I-195 Relocation - Contract 14(West side city streets)

NOTICE TO PROSPECTIVE BIDDERS

ADDENDUM NO. 2 Prospective bidders and all concerned are hereby notified of the following changes in the Plans, Specifications, Proposal and Distribution of Quantities for this contract. These changes shall be incorporated in the Plans, Specifications, Proposal and Distribution of Quantities, and shall become an integral part of the Contract Documents.

DESIGNED BY:
 CHECKED:
 DATE:
 SHEET: V1_088
 OF: V1_260

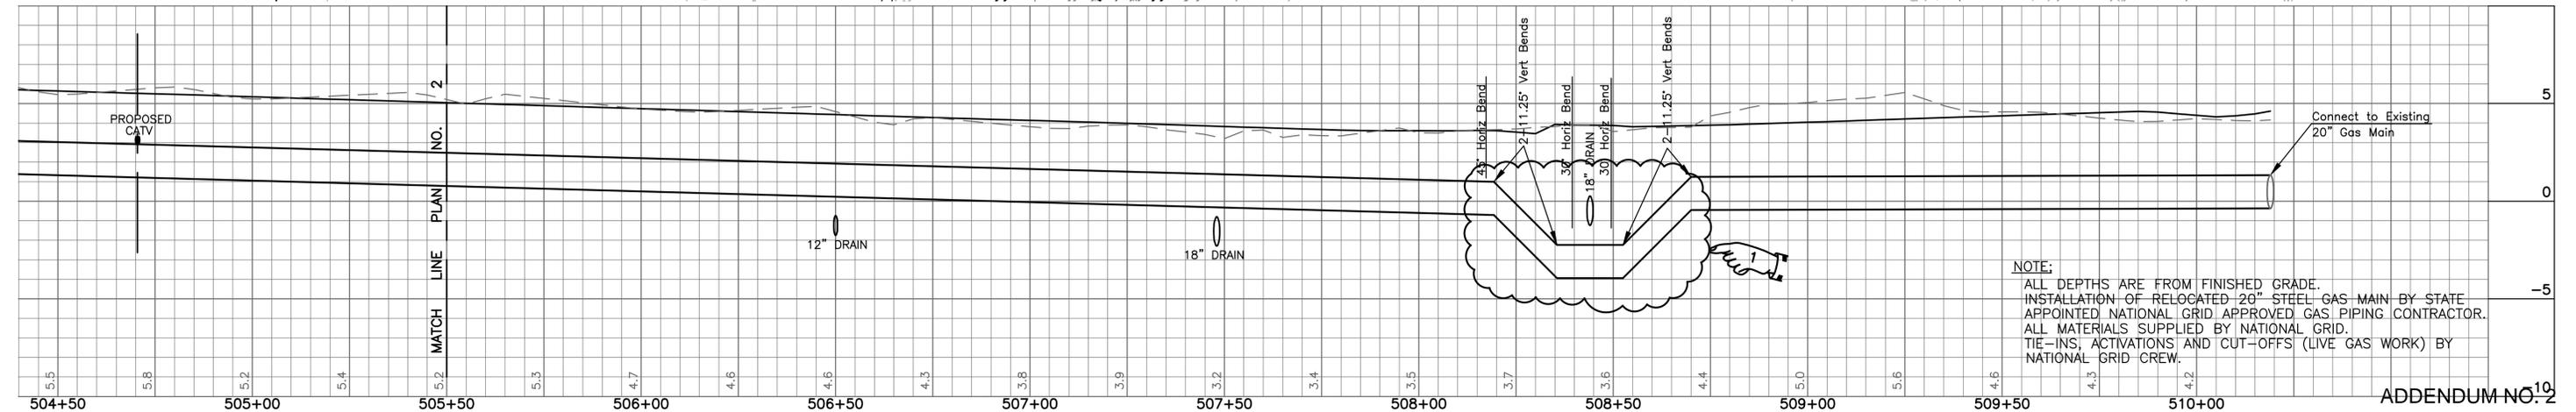
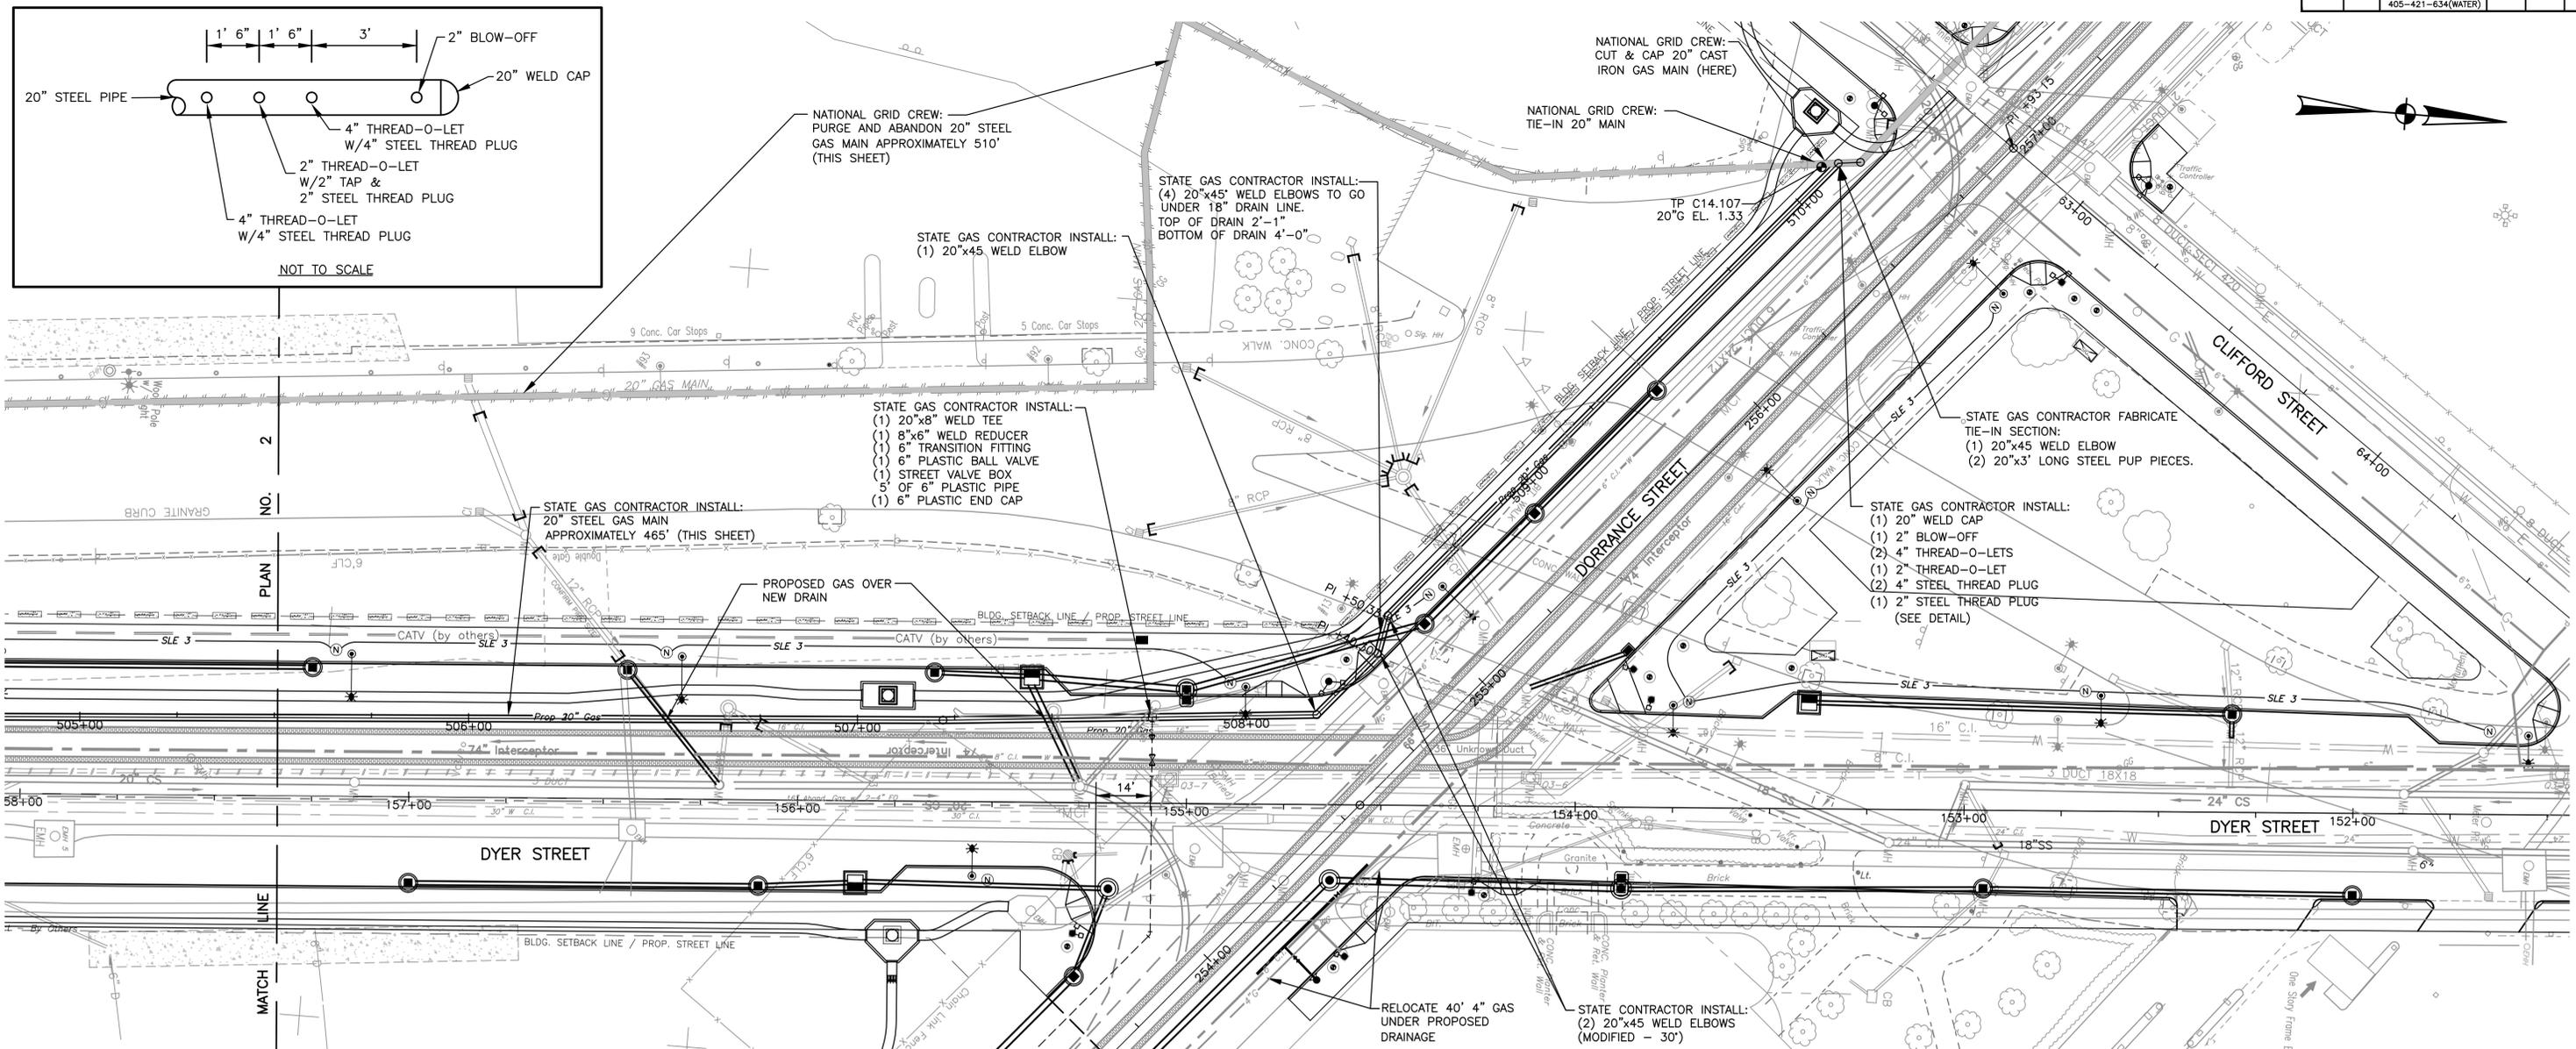
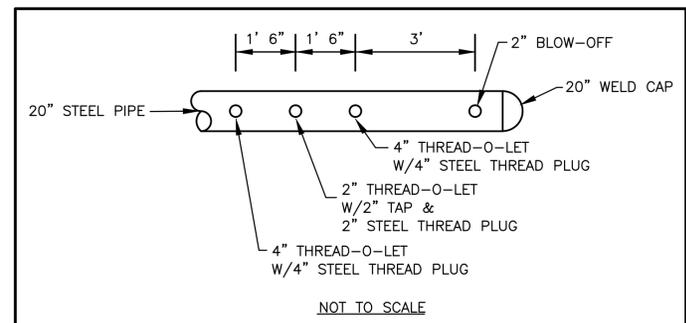
6. Sheet V1_088

Delete Sheet V1_088 in its entirety and replace it with Sheet V1_088(R-1) attached to this Addendum No. 2. The utility profile has been revised.

DESIGNED BY:
CHECKED:
DATE:
SHEET: V1_151
OF: V1_260

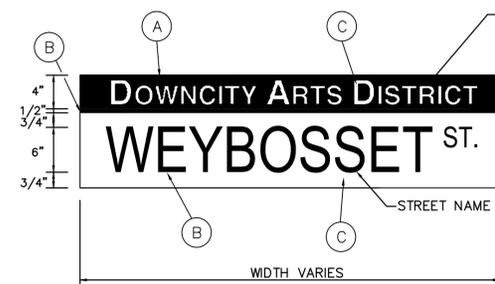
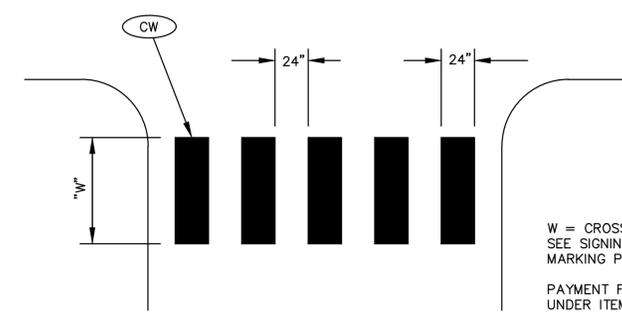
7. Sheet V1_151

Delete Sheet V1_151 in its entirety and replace it with Sheet V1_151(R-1) attached to this Addendum No. 2. Sign mounting notes and details have been added. Callouts have been added to the legend.
